COMPANY STATEMENT (Reference C5 Rattling issues)

Marshall Amplification plc recognises the need to clarify an issue related to the C5 product. Any action taken should only apply to units returned for servicing or raised as an issue by the customer. Units should not be re-called. This action is to reduce unacceptable rattling when unit is played.

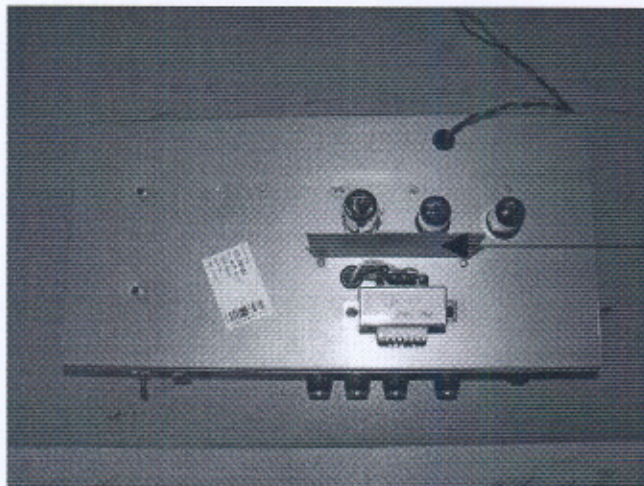
1. Initially check all screws and fixings are tight including Transformer screws, PCB fixing, Earth fixing, Pot nuts, jack socket nuts and the clip on the Red LED
2. Check all cable-ties are tight.

3. Ensure LED is held in firmly and clip is flush to the chassis. Production is now using hot-melt glue.

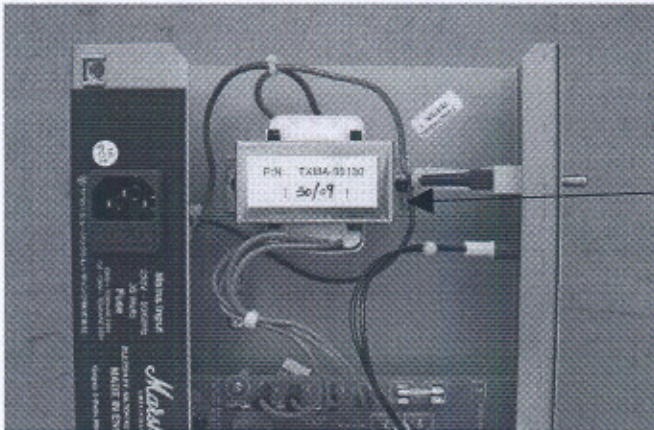
4. Remove heat shield if fitted.

5. Check mains transformer wires, they must not touch the chassis or sit above the top of the chassis, check no wires are touching the mains transformer.

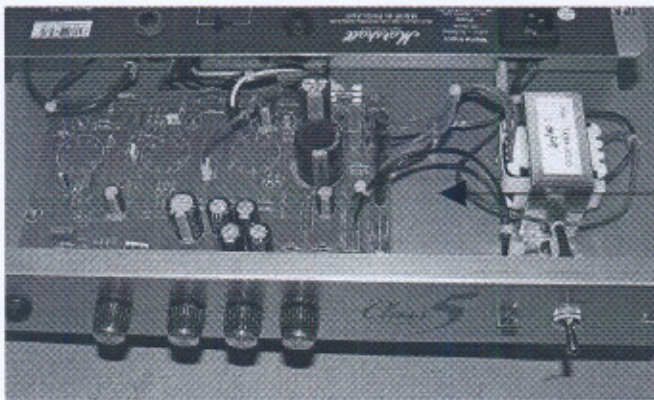
5a. Check no wires or cable-ties are touching the mains transformer

5b. Check no wires are touching the chassis

5c. Check no wires are sticking above the top of the chassis. Ruler used to distinguish line.

6.

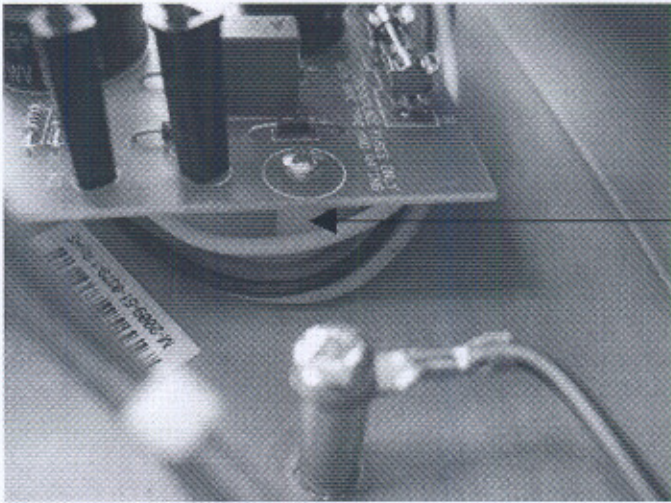
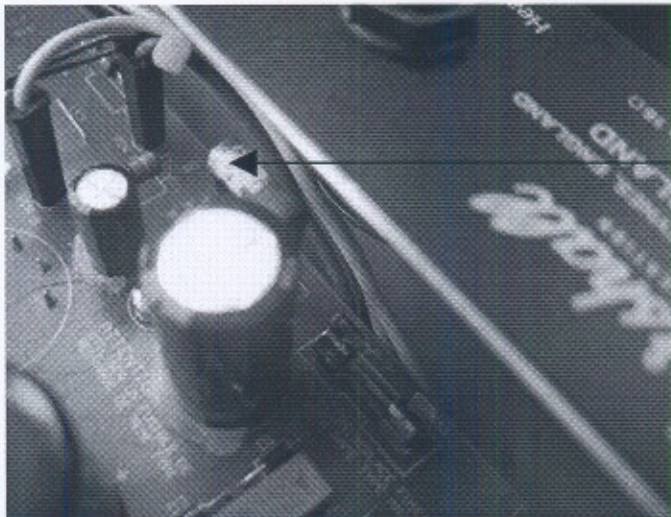
6a.
Output Transformer
wires; run the wires
around the end PCB
spacer

6b. Then along the
edge of the PCB
Route wires away
from resistor (R6)

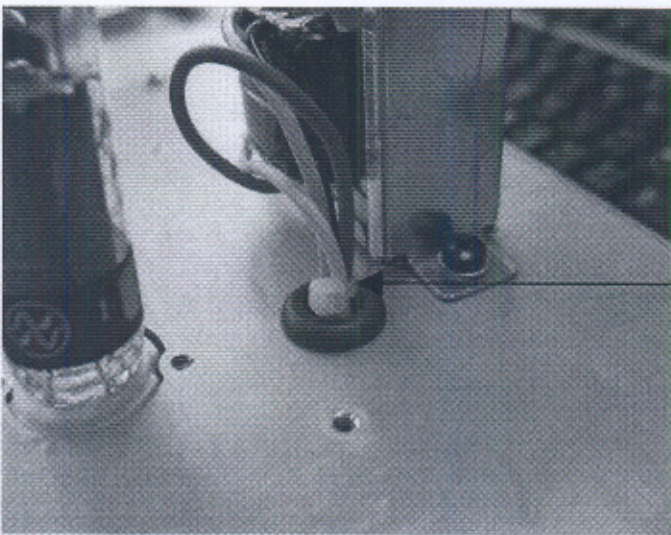
6c. Cable-tie (including the thin blue harness) close to the white & purple wire connectors

6d. Pull transformer wires gently out of the grommet by o/p transformer and fix with another cable-tie.

7.
rattle

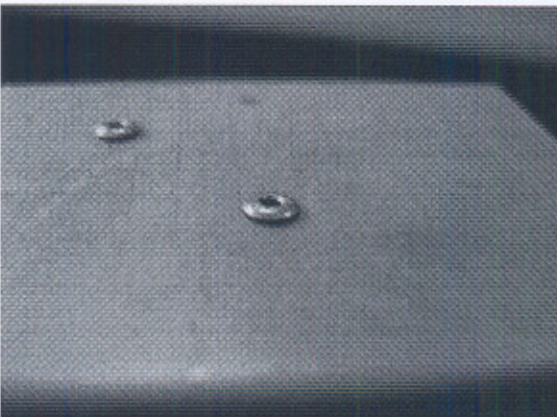
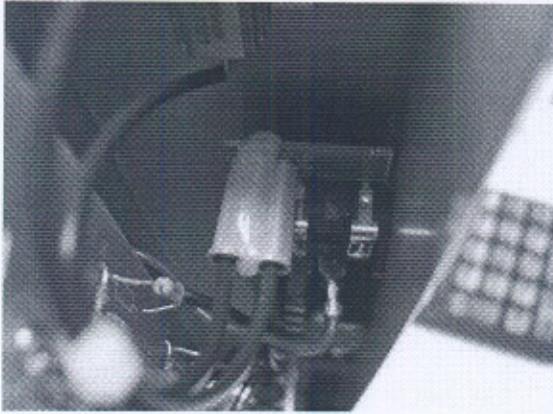
Check the resistor riveted to the chassis; if the resistor or rivets are loose and they can be glued, tightened by squashing the rivets with a pair of pliers or splaying the rivet out by tapping with a cross head screwdriver in the centre of the rivet. The grey connectors from the resistor must be fixed or glued together.
